Access Compliance Report

Public Rights-of-Way

Intersection ID: 8459	Main Street: KENTBROOK_DR	Cross Street: SPRINGVIEW_RD	Location: SW
ADA ID: 73935E254465	Ramp Type: BlendTrans1	Initial Pass/Fail: Fail	Overall Compliance: No
Severity Score: 21.25			
Codes/Mitigation Info/Possible Solution		Field Measurements/Component Compliance

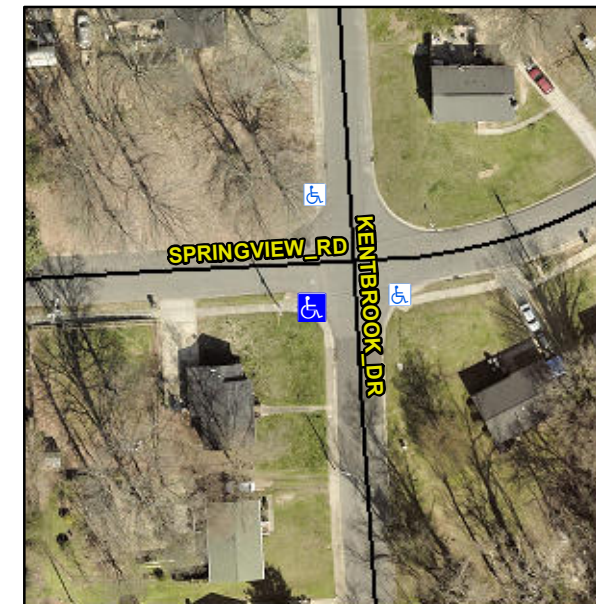
Not Found, R304.5.1, R304.5.3

Compliance	Description	Data	Compliance	Description	Data
N/A	Ramp Length (in)	52.0	Yes	BlendTrans Slope (%)	2.0
No	Ramp Width (in)	40.0	No	BlendTrans XSlope (%)	6.8
N/A	Flare Type LT	N/A	N/A	Flare Type RT	N/A
N/A	Flare Slope LT (%)	N/A	N/A	Flare Slope RT (%)	N/A
N/A	Flare Traversable LT?	N/A	N/A	Flare Traversable RT?	N/A
N/A	Landing Length (in)	N/A	N/A	DWS Provided?	N/A
N/A	Landing Width (in)	N/A	N/A	DWS Contrast?	N/A
N/A	Landing Slope (%)	N/A	N/A	DWS Length (in)	N/A
N/A	Landing X Slope (%)	N/A	N/A	DWS Full Width?	N/A
N/A	Landing Curb? (Y/N)	N/A	N/A	DWS Offset (in)	N/A
N/A	Shared Landing?	N/A			
N/A	Gutter Ponding?	N/A	N/A	Gutter Slope (%)	N/A
N/A	Gutter Lip Ht (in)	1.0	N/A	Gutter X Slope (%)	N/A
N/A	Painted X Walk1?	No	N/A	Painted X Walk2?	No
	X Walk 1 Direction	To E		X Walk 2 Direction	To N
	X Walk 1 Width (in)	N/A		X Walk 2 Width (in)	N/A
	X Walk 1 Slope (%)	4.0		X Walk 2 Slope (%)	7.8
	X Walk 1 X Slope (%)	7.3		X Walk 2 X Slope (%)	1.6

N/A	Ramp inside XWalk1?	N/A	N/A	Ramp inside XWalk2?	N/A
	Road Slope (%)	6.0		Clear Space?	N/A
	Road X Slope (%)	8.8	N/A	Clear Space to XWalk (in)	N/A
N/A	Any Obstructions?	N/A	N/A	Storm Grate/Utility Hazard?	N/A
	Obstruction Type			Storm Grate/Utility Type	
		N/A			N/A
			Yes	Surface Condition? (G/P)	Good
			No	Curb Slope (%)	23.4

Remove & Replace Curb Ramp With Two New Directional Ramps or Equivalent.
